Certified Action of the City of Raleigh Planning Commission

Case File / Name: SP-28-10 / SECU - Salisbury Street - Revision

SP-28-10 / SECU Salisbury Street - Revision – Preliminary Site Plan

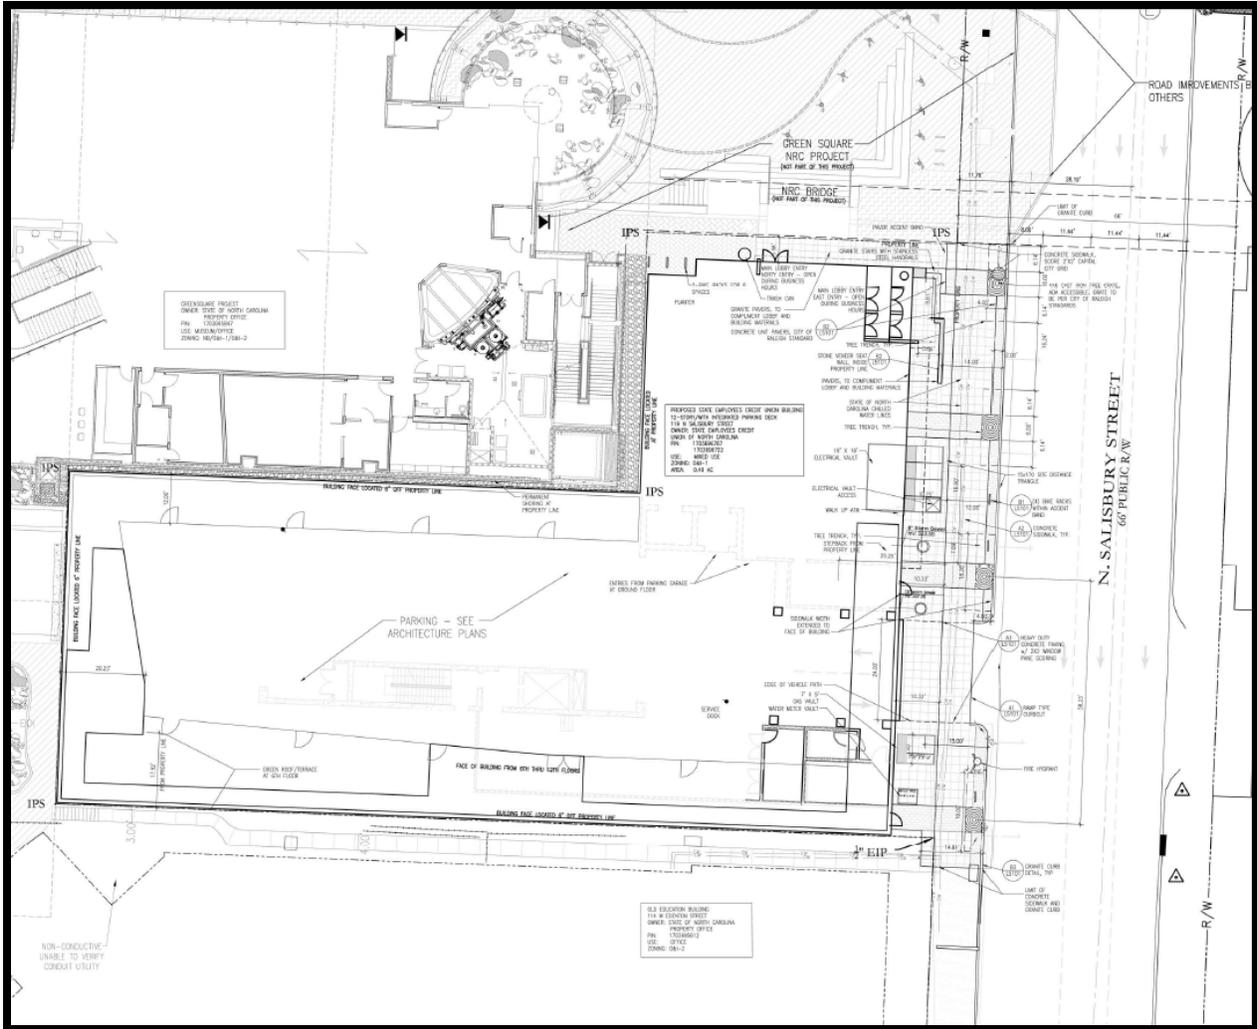
The southern portion of the project features a setback in the form of a terrace at the 6th floor, however the northern tower portion of the project does not feature any setbacks or articulation to mitigate wind effects, but does feature a canopy at the ground floor level.

- The horizontal lines of the parking garage are near the horizontal lines on the Old Education Building, but are not the same. Concern was expressed that they may read as a "near miss."

- Applicant Response: Reveal added to better align with the cornice of the Old Education building
- The materials and style of the parking deck contrasts with the materials and style of the tower such that the building seems to be two pieces. It was suggested that the horizontal lines connecting the pieces could be carried further to tie them together.

- The height and verticality of the northern portion of the project is somewhat troubling. Except for the Albemarle Building at 11 stories, the nearby buildings are a maximum of 6 stories. The Archdale Building is too distant to be relevant in comparison.

- Applicant Response: Our project is located between two state buildings that are very different in character. We are making every attempt to respond to the Old Education Building through the use of similar materials, horizontal lines and window openings. We have revised our elevations to include the jointing of the stone at the parking deck which relates to the mullions in the curtain wall at the entry and atrium to the north and ties that stone and glass together. The reveals in the stone at our parking deck have also been enlarged in an attempt to match the scale of the cornice lines on the Old Education Building.

- Applicant Response: Long range plans for this by the State of North Carolina and private development is to build taller buildings as the city continues to infill its urban core. The height was approved previously by Planning Commission and City Council.
